JOINT REGIONAL PLANNING PANEL REPORT

OCTOBER 23 2014

Development Application No.	➤ D/2014/312
Address	➤ 22 George Street, LEICHHARDT NSW 2040
Description of Development	➤ Site preparation works (including diversion of services, remediation, demolition of existing structures and excavation) and construction of a mixed use development of 5 buildings of 4 to 9 storeys in height. The buildings shall comprise 2 commercial tenancies and 290 residential units above a basement car park containing 283 parking spaces. Associated landscaping and public domain works.
Date of Receipt	➤ 27 June 2014
Value of Works	➤ \$98,500,000
Applicant's Details	➤ Greenland Sydney George Street Development Pty Ltd C/- Alexander Rodakis Suite 201, Level 2 233 Castlereagh St SYDNEY NSW 2000
Owner's Details	➤ KGS Victoria Pty Ltd C/- Sweetvale Pty Ltd, Att: Tim Selleck Level 9, 161 Collins St MELBOURNE VIC 3000
Notification Dates	➤ 17th July 2014 to 28th August 2014.
Number of Submissions	➤ 98

Main Issues	➤ Contamination, flooding, amenity, zone objectives, non-compliance with SEPP, LEP and DCP.
Recommendation	➤ Refusal

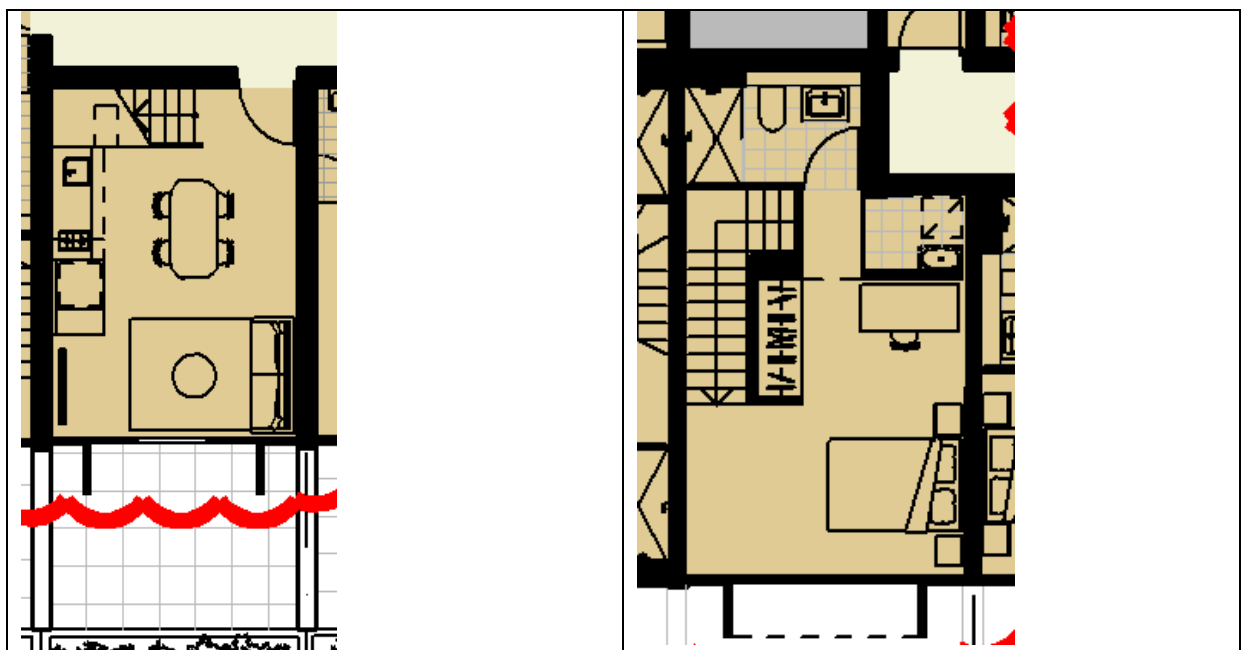
Buildings A and D exceed the recommended depth (22m each). Council staff continue to be concerned regarding the amenity of some of the dwellings contained in these buildings.

Apartment layout: The various iterations of the proposed floor plans have not entirely overcome Council's initial concerns with regard to dwelling amenity. Coupled with the building depths, which in several instances exceed the Guideline recommendation of 18m, numerous dwellings continue to have internalised "studies" with little to no direct access to natural light and ventilation (see figure below). This is particularly true of those buildings A and D which exceed the 18m depth rule of thumb – Buildings A and D have depths up to 22m.

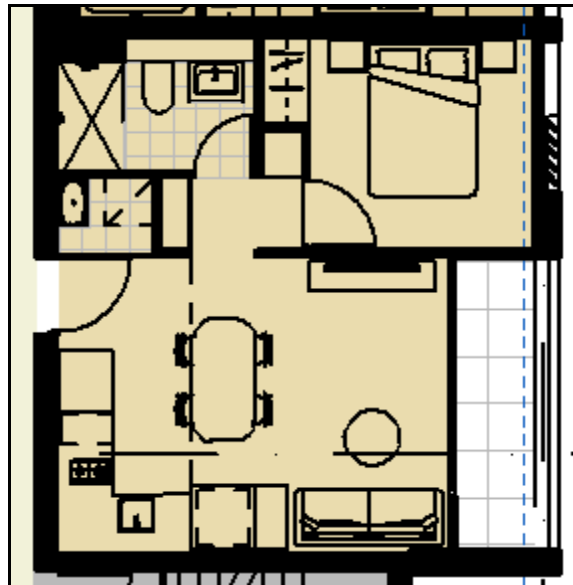
Also, the Revision B plans, which inserted two additional units, have resulted in two dwellings being quite small in area, and single aspect. See below.

Internal living/kitchen/dining space measures 4m x 4.6m (excluding stairs) – bedroom level is 23.57sqm – total GFA is 42sqm. Under the rules of thumb a one-bedroom single aspect maisonette style dwelling unit should be not less than 62sqm in area.

Diagram: Amended entry layout to basement car park – pedestrian access separated - building footprint east-west reduced and communal space opened up

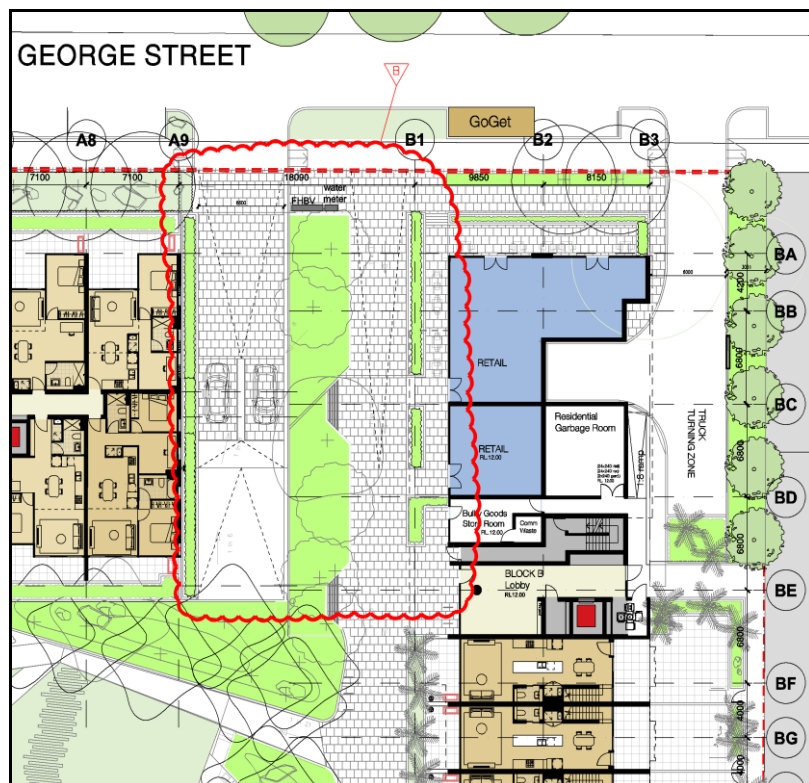
In terms of the redistribution of floor space/building height, it is considered that such redistribution would have to be equal to or better than the DCP provisions, in terms of meeting the objectives, if it was to warrant support. The modified design is demonstrated below.

Council accepts that the applicant's preferred design results in better amenity outcomes for users of the plaza, through-link and retail/café tenancy, as this area would be less visually overwhelmed and much less overshadowed. The modification also allows the north facing units of Building B to have largely unfettered solar access.

DCP setback recommendations Applicant's alternative with greater setbacks

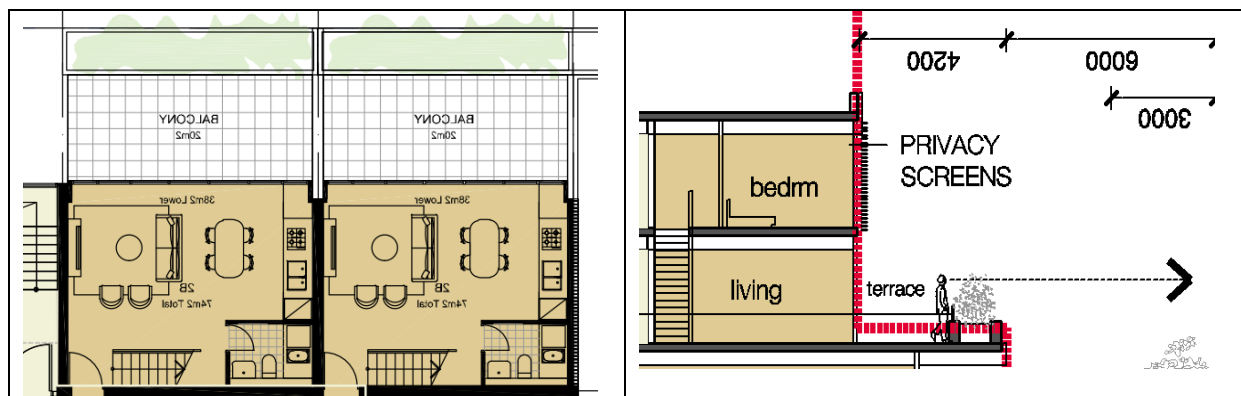
The addition of these two extra storeys does not result in additional overshadowing to the rear of the Flood St neighbours, partly because the design has incorporated greater setbacks from the George Street boundary than the DCP suggests.

Diagram: Distance from (only) balcony to nearest bedroom is 7.8m

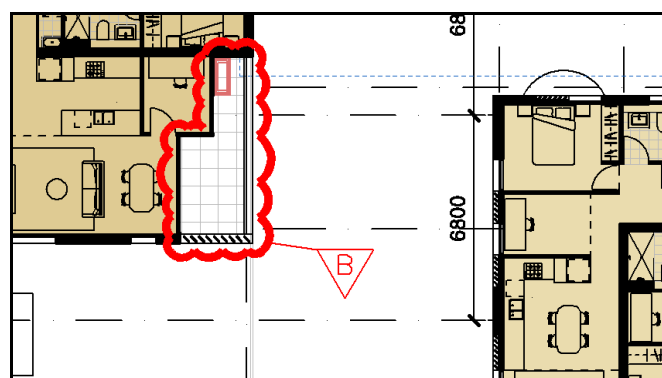
The separation of buildings in the proposal is not entirely consistent with either the SEPP or the DCP. For example, Building A (6 storeys) is only separated from Building B (9 storeys) by 18m from habitable room to habitable room/balcony. This is acceptable for buildings up to eight storeys but is less than the 24m required for buildings eight storeys or greater. Building D and E are only separated by 9.3m instead of the 12m nominated in the SEPP. Building B (9 storeys) and Building C (6 storeys) are only separated by 7.8m at the closest point instead of 18m.

It seems likely that the lack of separation is contributing to some less than desirable amenity outcomes for internal occupants of the site, particularly with regard to visual and acoustic privacy. It is unclear, for example, how the lack of separation between Building B and C could be appropriately managed to achieve reasonable amenity outcomes (see figure below for example)

Unless the design can demonstrate good outcomes in terms of solar access, visual and acoustic privacy, Council is of the opinion that given the proposal seeks the benefit of a varying number of storeys greater than the DCP guidelines, it should also be bound by the burden inherent in achieving those greater number of storeys.
